BELL SYSTEM PRACTICES
Plant Series

Appendix 1, Section 573-118-800 Issue 2
Teletypewriter Change Notice
TCN 1862 Issue 1
November, 1973
AT&T Co Standard

PART AFFECTED: TP164386 Magnet Mounting Bracket

TP164386 MAGNET MOUNTING BRACKET

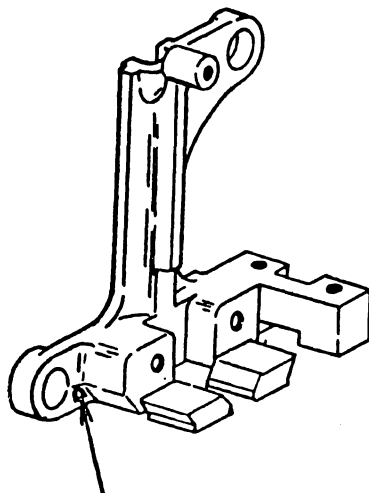
REASON: To prevent first character garble due to armature sticking to pole pieces on the selector magnet assembly.

CHANGE: The manufacturing process for the TP164386 magnet mounting bracket is revised to eliminate the substance that causes the armature to hang up.

IDENTIFICATION: The TP164386 magnet mounting brackets manufactured by the revised process can be identified by the presence of a blue dot near the lower mounting hole. See Attachment Sheet 1.

**BLUE DOT IN THIS AREA INDICATES
TP164386 MAGNET MOUNTING BRACKET
MANUFACTURED BY THE REVISED PROCESS.**
